विषय :- आनलाईन प्रस्ताव लोहारी-सिल्ली-बन्ड कनस्यारी मोटर-मार्ग (प्रस्ताव संख्या 11030/2015)।

संदर्भ :- आपकी आपत्ति दिनांक 07.10.2015।

LOHARI -
NAME OF WORK:- CONSTRUCTION OF SILU-BUND-KANSYARI MOTOR ROAD

MUCK DISPOSAL PLAN

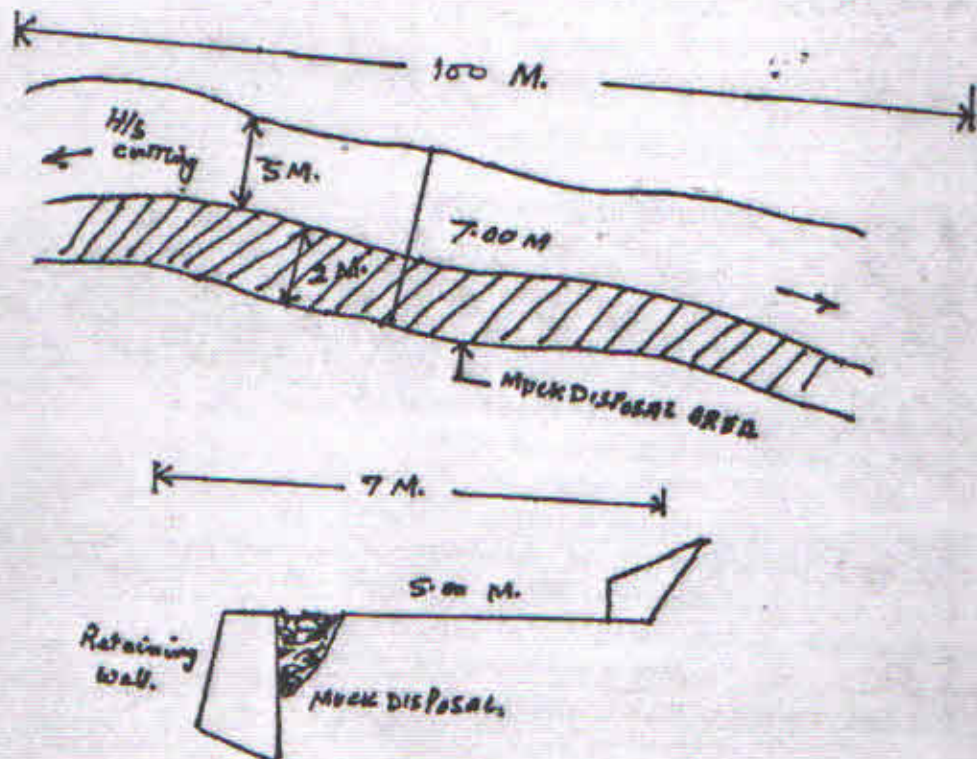
4	The total of village wise break up of land proposed for diversion is 1.4105 ha. While the total land asked for diversion is 1.747 ha clarify the discrepancy.	Total land for diversion as per village wise breakup comes 1.747 hec which is correct . In land schedule against khasara no. 1737 of village Silli proposed land is 0.055 hec. Instead of mentioned 0.035 hec. Due to typing mistake.A correct copy is being uploaded again.
5	The area marked for Muck dumping is at khad side but it is not mentioned that whether the area is included in existing ROW and the status of FCA applicability on such land. Need to be clarify.	Muck dumping site selected in khud side of the proposed motor road in km 1,4,6,& 8 with in 07 M. width comes within FCA. The ares for muck dumping site is already included in land schedule of state land. Detail drawing is being uploaded.
